Docket Number:	97-AFC-02C
Project Title:	Sutter Power Plant Application for Certification
TN #:	259750
Document Title:	Sutter Decarbonization Project Data Response Set 1
Description:	Responses to Data Requests A1 to A8
Filer:	susan fleming
Organization:	California Energy Commission
Submitter Role:	Commission Staff
Submission Date:	10/29/2024 12:05:37 PM
Docketed Date:	10/29/2024

Data Response Set 1 (Responses to Data Requests A1 to A8)

Sutter Decarbonization Project
(97-AFC-02C)
October 29, 2024

Figure 1. Total integrated mass injected over three lateral injection wells screened in the Starkey Clean Sand.

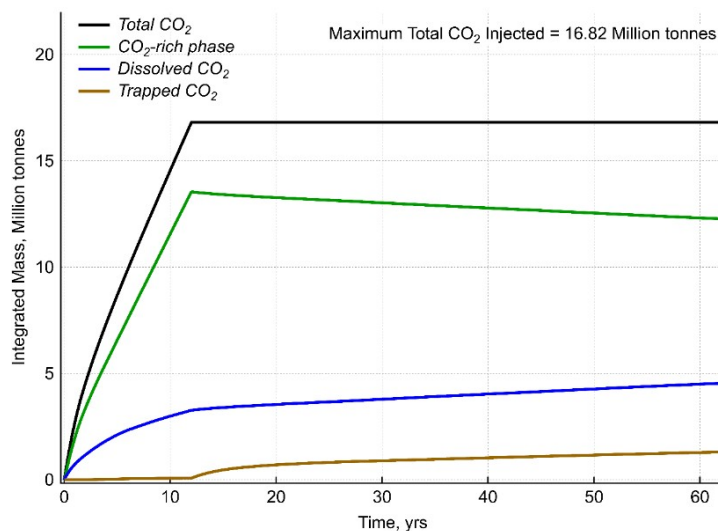
A8. Assuming the Starkey Formation is continuous as suggested by local E-Logs, please describe how injected carbon dioxide would be contained laterally.

Figure 1 shows the total mass of injected CO₂ over time, and the proportion of that which is in the supercritical gas phase and the dissolved phase. Note that the trapped gas shown in the figure exists in the CO₂-rich phase and is therefore included in the mass of CO₂ in the CO₂-rich phase shown in the plot. Most of the CO₂ mass occurs in the CO₂-rich (or separate) phase, with about 25 percent occurring in the dissolved phase at the end of the simulation period. Note that once injection ceases, residual trapping begins to take place, resulting in about 7% of the total CO₂ mass being immobile at the end of 62 years. The total mass injected by each well is shown in [Figure 2](#).
